Subject: MHI's Response to US-APWR DCD RAI No. 297-2287 Revision 2

MHI's Response to US-APWR DCD RAI No. 297-2287 Revision 2

**US-APWR Design Certification
Mitsubishi Heavy Industries
Docket No. 52-021**

RAI NO.: NO. 297-2287 REVISION 2
SRP SECTION: 15 – INTRODUCTION – TRANSIENT AND ACCIDENT ANALYSES
APPLICATION SECTION: 15.0.0
DATE OF RAI ISSUE: 5/04/2009

Figure 15.0.0-3.27 RCP Outlet Pressure versus Time with and without LOOP Loss of External Load - RCS & Main Steam Pressure Analysis

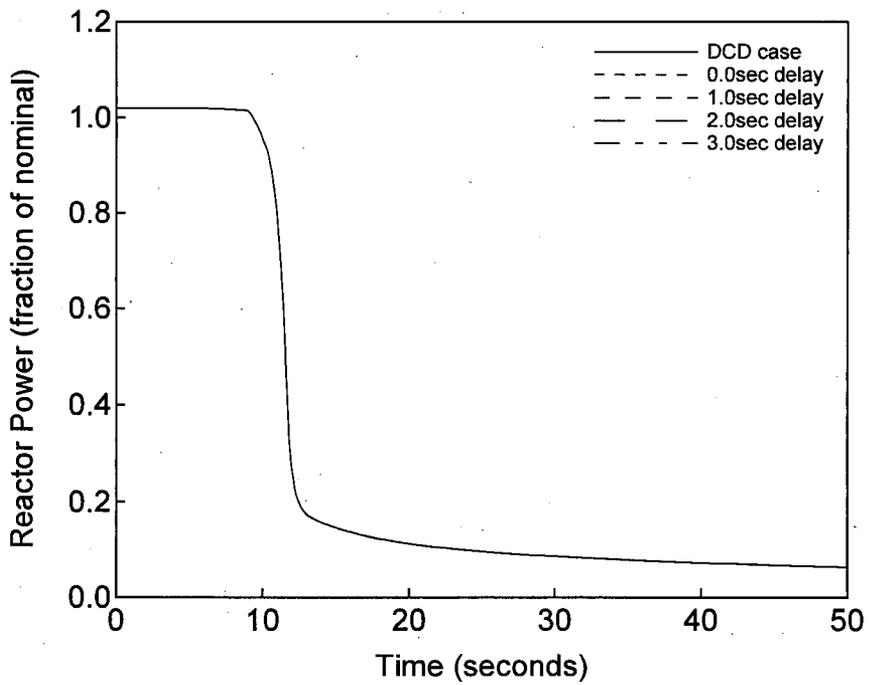
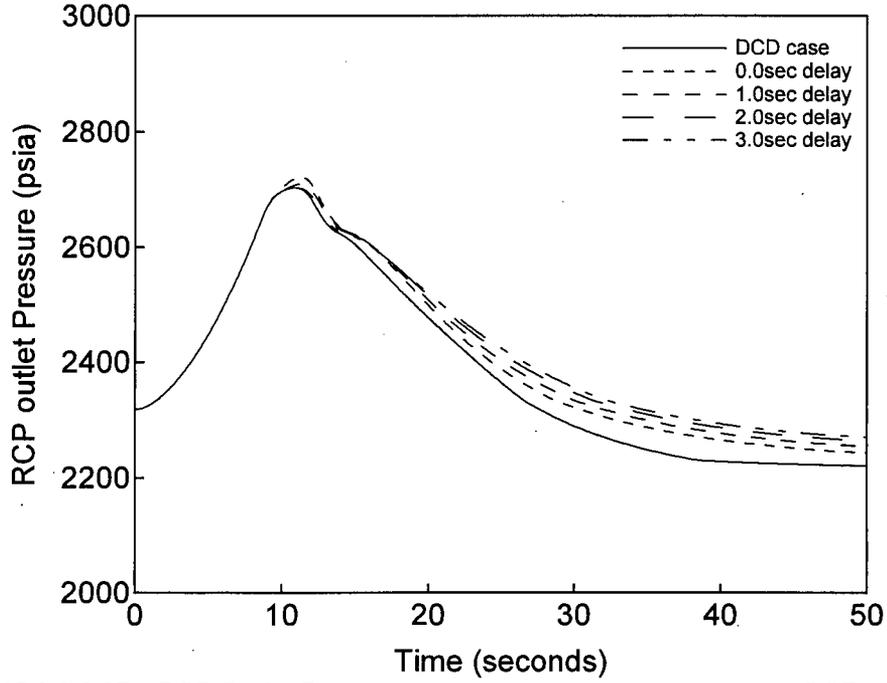
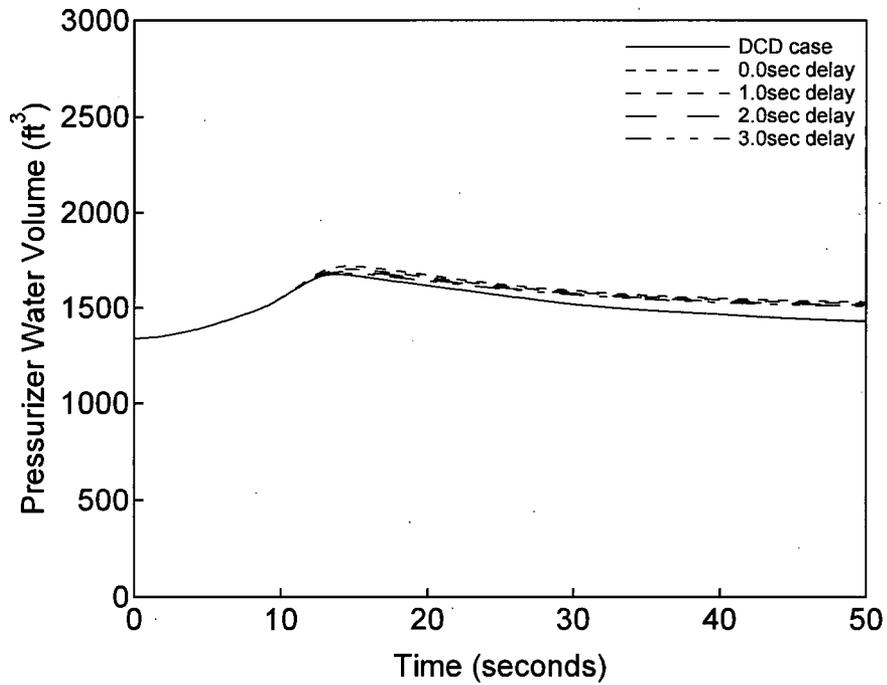
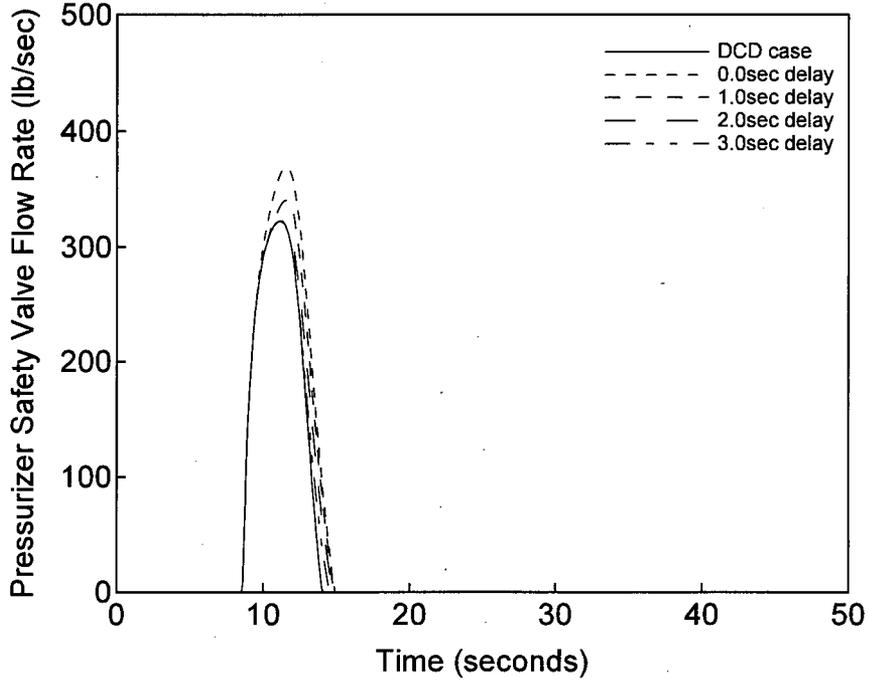
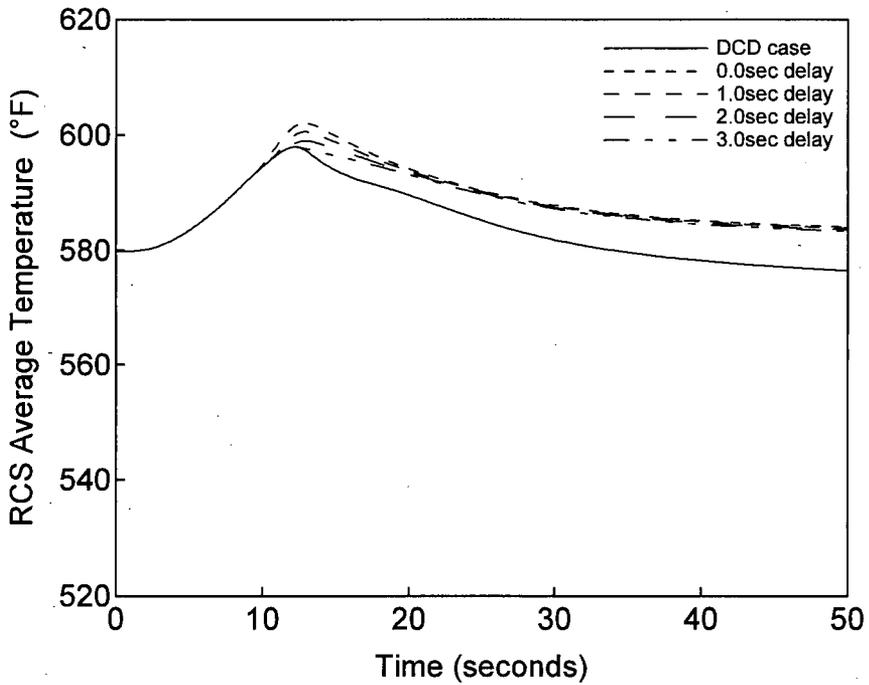
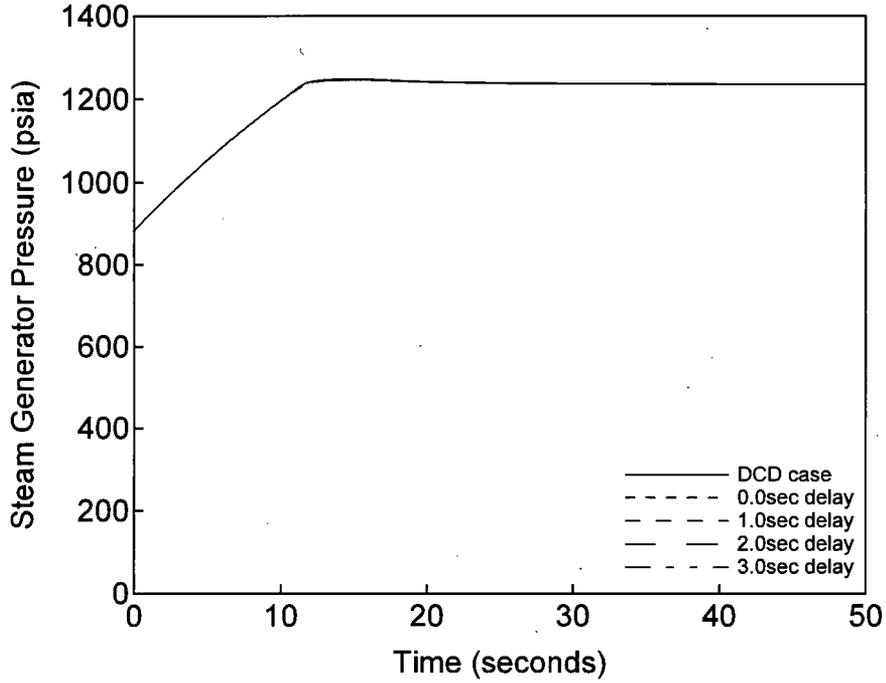
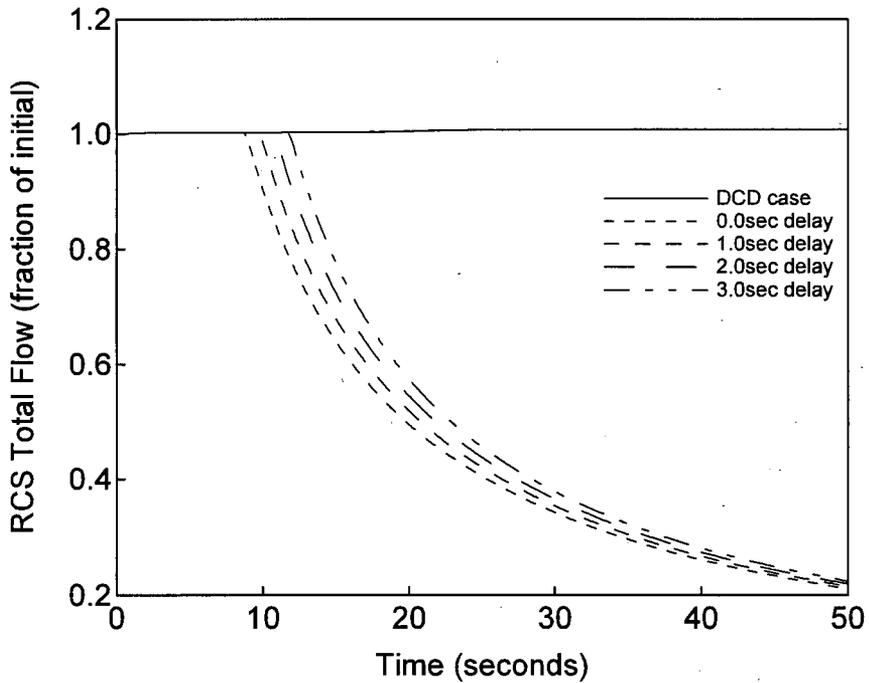
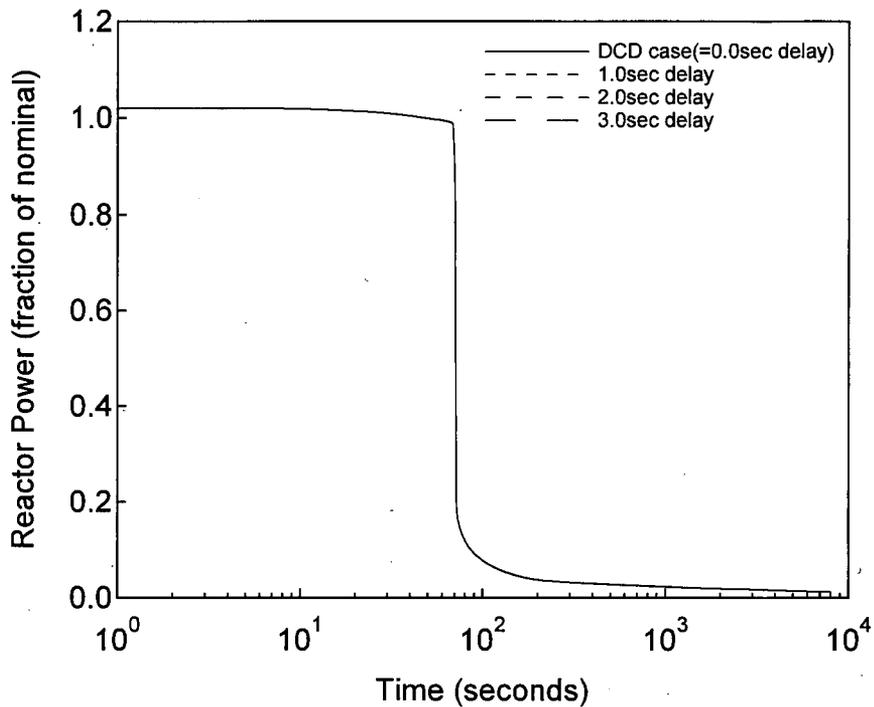
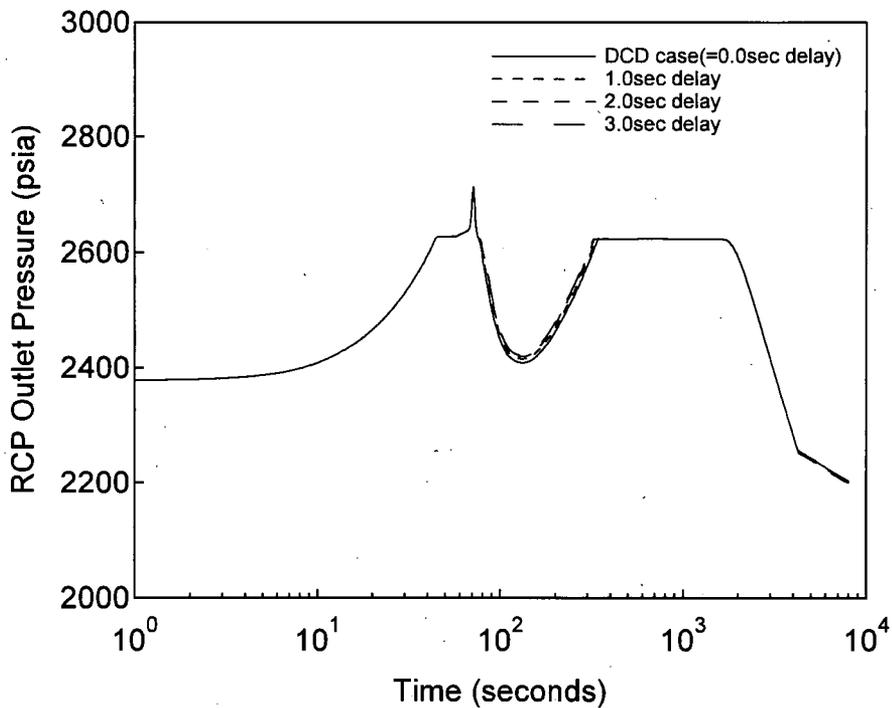
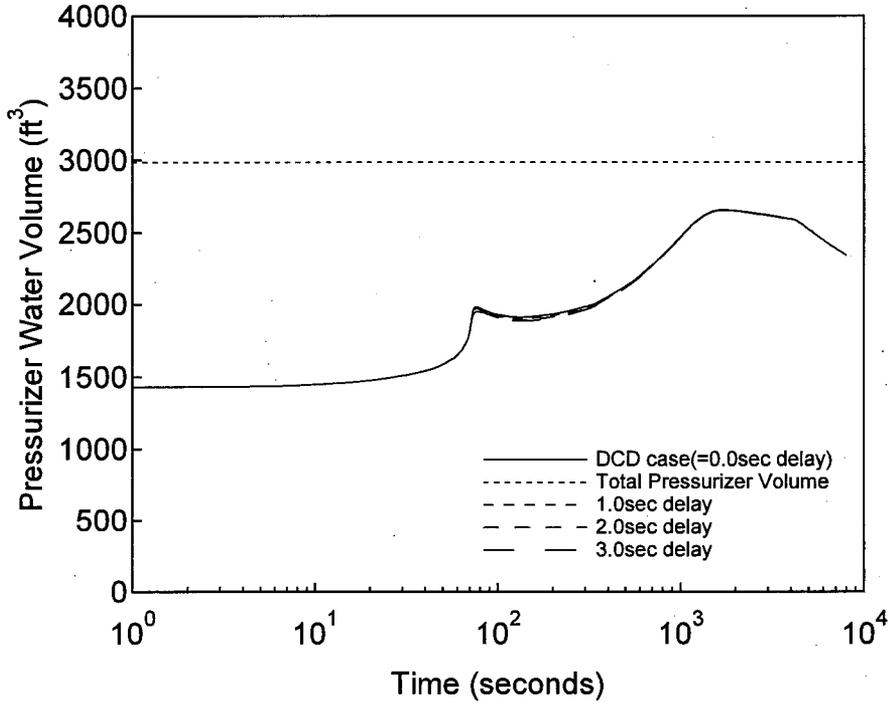
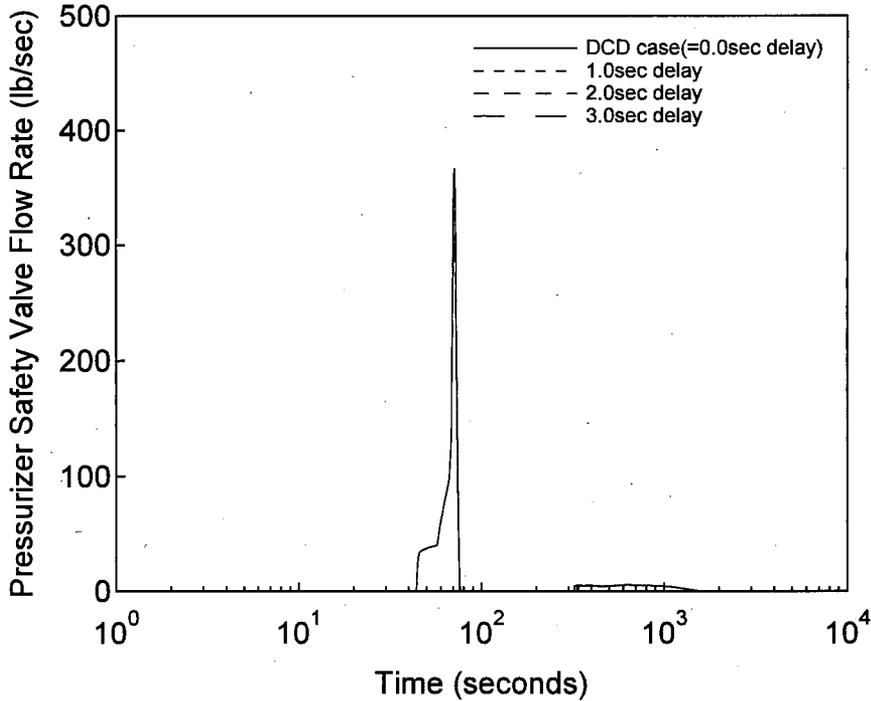
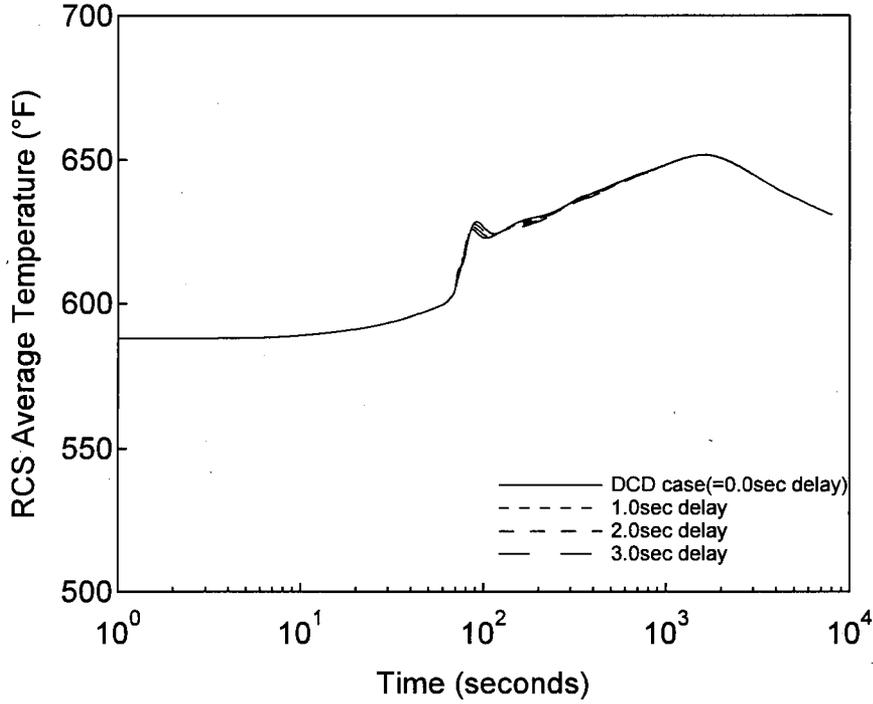
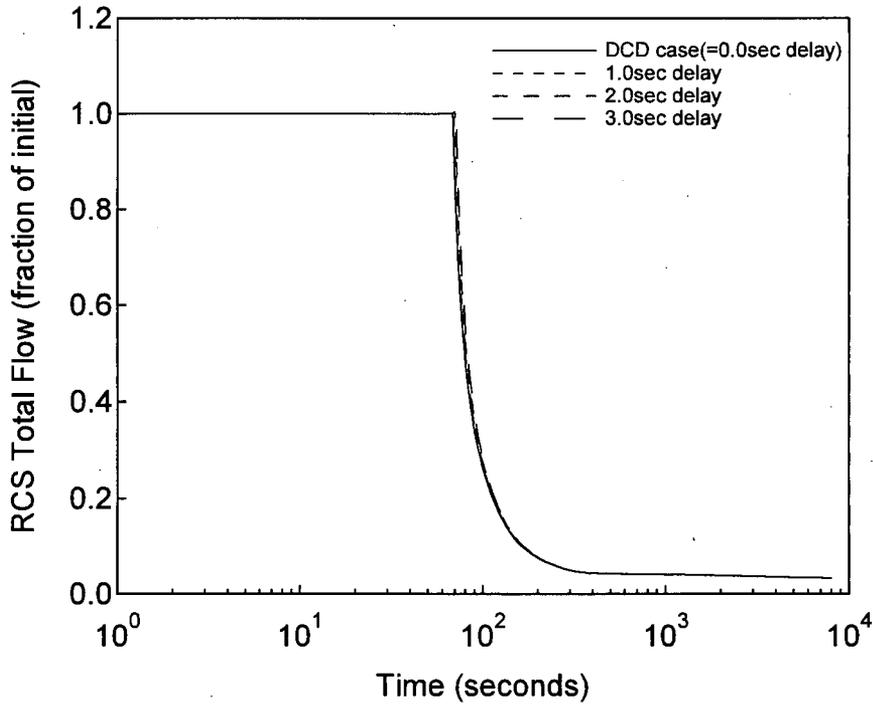
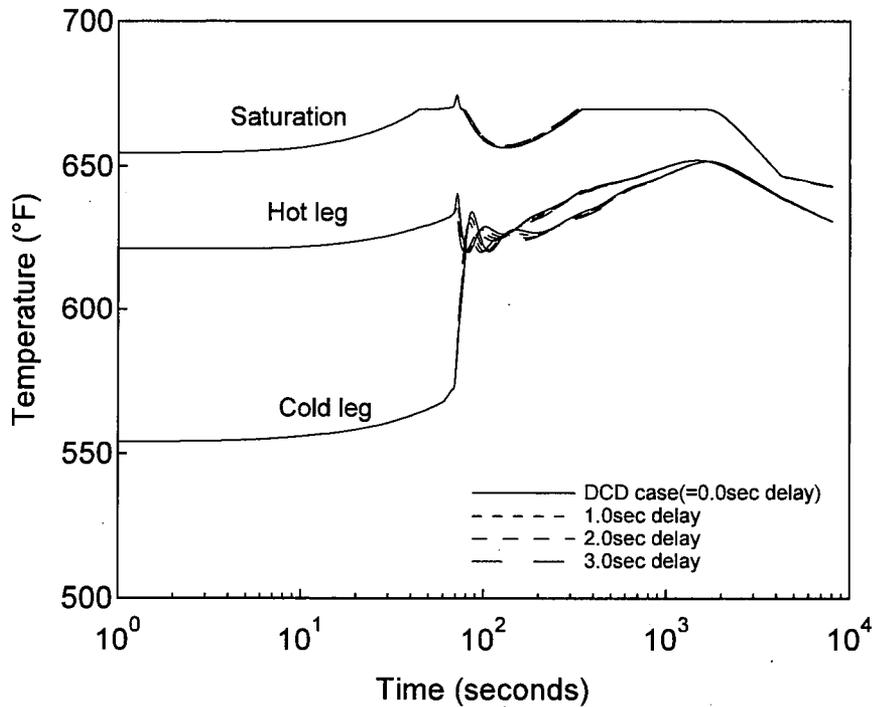
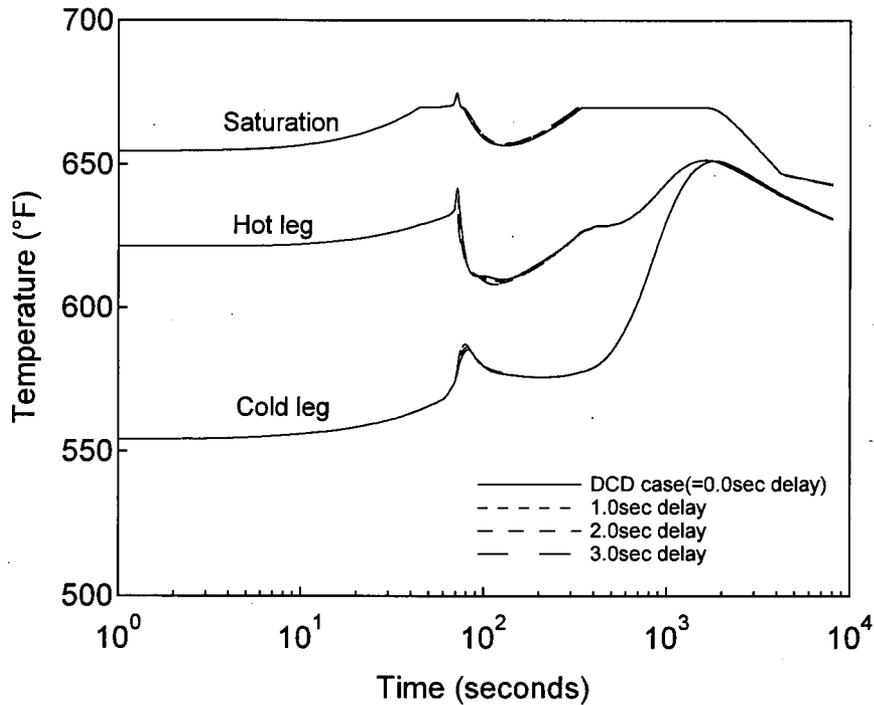
In DCD Section 15.0.0.7, the applicant presents arguments concerning the timing of a LOOP with respect to the timing of reactor trip and RCP coast down. By assuming a time delay in the onset of a LOOP, the onset of DNBR is decoupled from the availability of offsite power because the rods are inserted to the dashpot by the time the LOOP is initiated; therefore, the RCPs continue to run until the rods have been inserted in the core. This argument repeats itself throughout many Chapter 15 scenarios, allowing for the neglect of any LOOP consequences. Please provide more substantial arguments in defense of this assumed time delay, supported by sensitivity calculations that directly address this issue. (see also Question 15.1.2-1).

Two representative events were evaluated using MARVEL-M to assess the impact of the assumed LOOP delay time on the peak pressure: loss of load (Subsection 15.2.1) and feedwater line break (Subsection 15.2.8). Transient results for the key analysis parameters for the loss of load event with LOOP are provided in Figures 15.0.0-3.26 through 15.0.0-3.32. For the RCP outlet pressure shown in Figure 15.0.0-3.27, the cases with 2 and 3 second delay times have peak pressures that

are bounded by the DCD case, while the cases with 0 and 1 second delay times have slightly higher peak pressures than the DCD case. However, the difference in peak pressure is very small and in all cases, the peak pressures meet the relevant acceptance criteria. Transient results for the key analysis parameters of the feedwater line break event with LOOP are provided in Figures 15.0.0-3.33 through 15.0.0-3.44. It is important to note that the DCD feedwater line break case already assumes LOOP occurs with a 0 second (as opposed to a 3 second) delay time. The figures show that all parameters are mostly insensitive to the LOOP assumption. The relatively small differences in LOOP delay times are insignificant compared to the relatively long duration of the feedwater line break event. The DCD case shown in Figure 15.0.0-3.34 (which assumes a LOOP with 0 seconds delay) does have a slightly higher peak RCP outlet pressure than the other cases, but in all cases, the peak pressures meet the relevant acceptance criteria.

The results of the peak pressure analysis of these two events show that peak pressure is not as sensitive as DNBR to the LOOP assumptions. With a 3, 2, or 1 second delay between the turbine-generator trip and LOOP, the peak pressure is the same for the case with and without LOOP. The peak pressure is slightly higher for the 0 second delay case, but still within the acceptance criteria. Since the two events selected for this sensitivity analysis were the most limiting peak pressure events in Chapter 15, the remaining peak pressure analyses in Chapter 15 would also be adequate regardless of the assumptions about the LOOP delay time. While the results of this sensitivity analysis show that the DCD analyses meet the acceptance criteria, the description of the LOOP assumptions for peak pressure analyses in DCD Section 15.0.0.7 will be revised to more accurately describe the results of this sensitivity study.
